Conroys Gap Wind Farm Stage 2 (EPBC 2013/6989)

The exhibition of the Preliminary Documentation (Additional Information report) for a period of 20 business days resulted in the submission of one set of comments. A summary of the comments and how they have been addressed is provided in the table below.

Potential Offset Areas

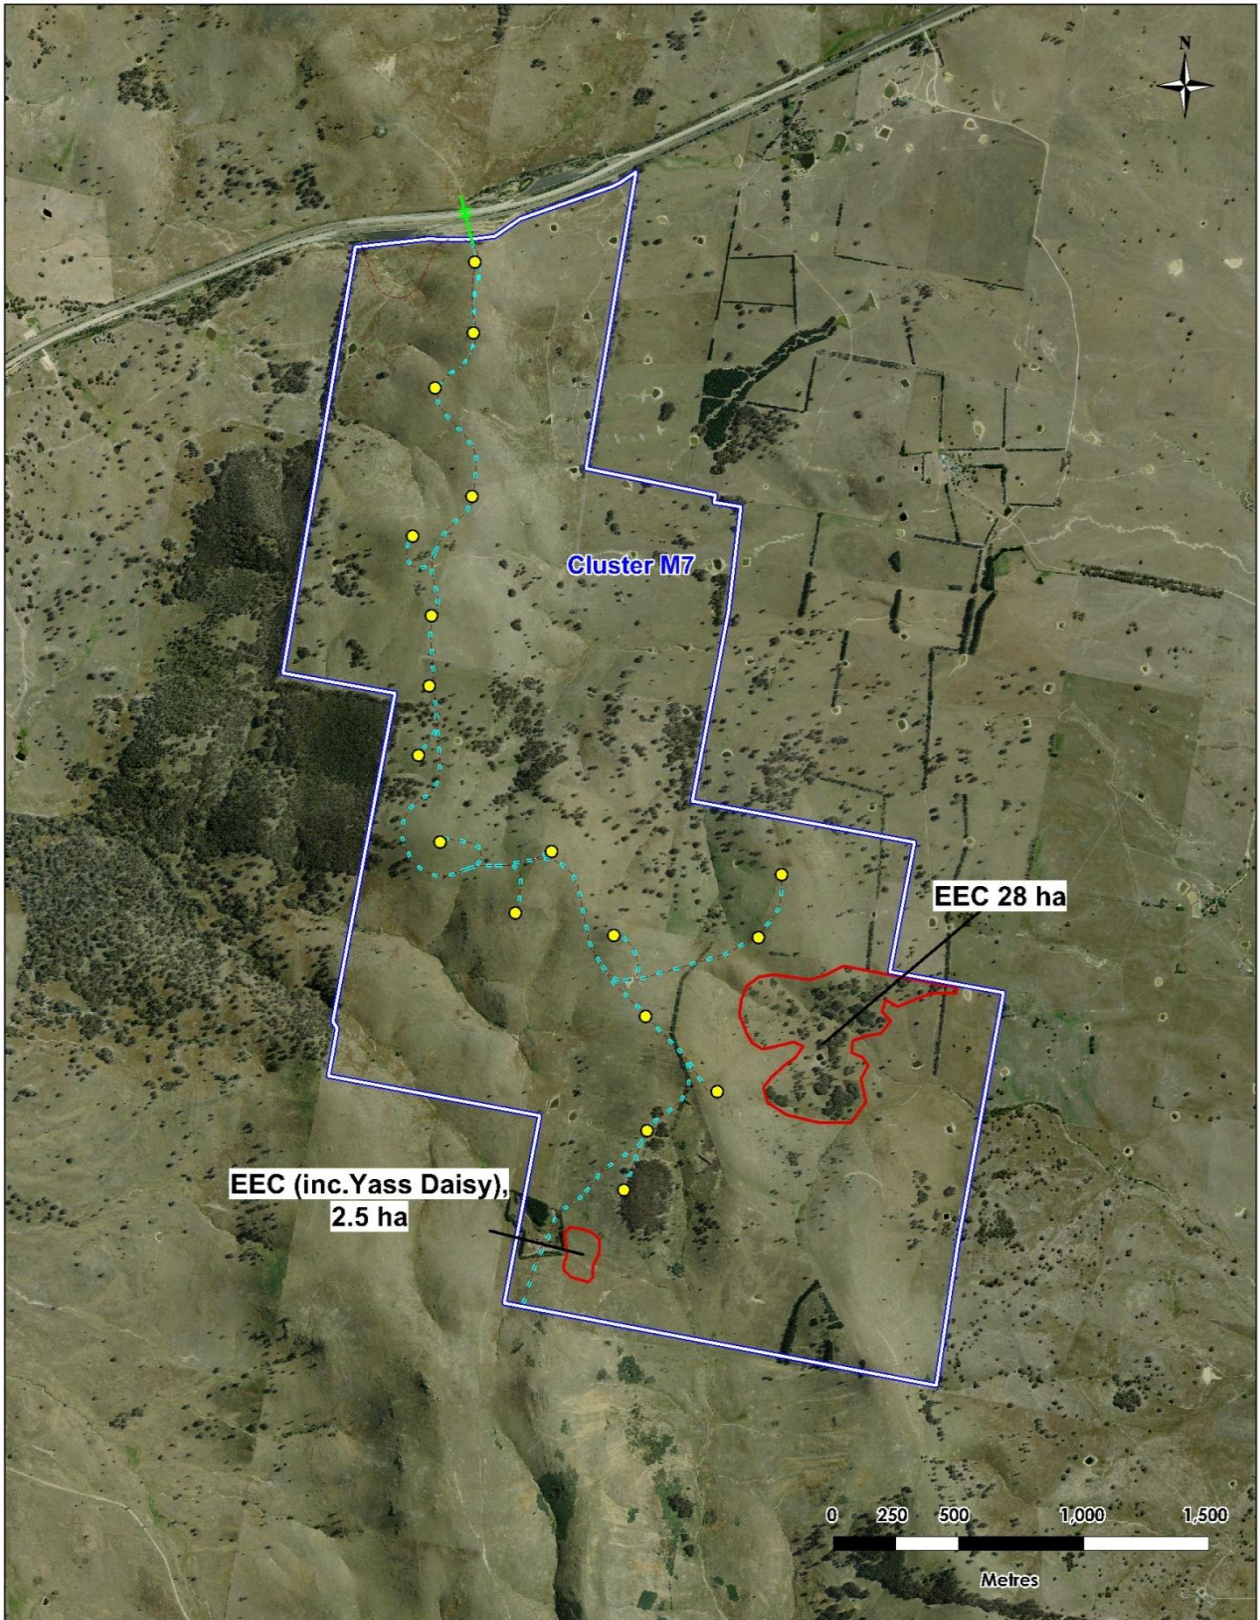
Comment summary	Response
1.	<p>Epuron has inappropriately claimed approximately 4 hectares of my property as a "Proposed Offset" area without permission, agreement or lease (refer pp 101 EEC Offset Area 9.0 ha);</p>	<p>The inclusion of the 9 ha offset area outside the project boundary on the map on page 101 was an error. There are other suitable areas within the project boundaries that could be used for biodiversity offset areas. Refer to revised map of potential offset areas attached.</p> <p>A final offset package will be prepared in consultation with relevant government agencies and affected land owners. The purpose of the offset discussion in the exhibited report is to show that land that is suitable for offsets is available within the project boundaries. The aim was to demonstrate offsets are feasible and not to lock in final offset areas. The report states:</p> <p><i>A site has yet to be identified, but there is ample land of suitable type within the project boundaries to demonstrate that offsets are achievable for EPBC affected species.</i></p>
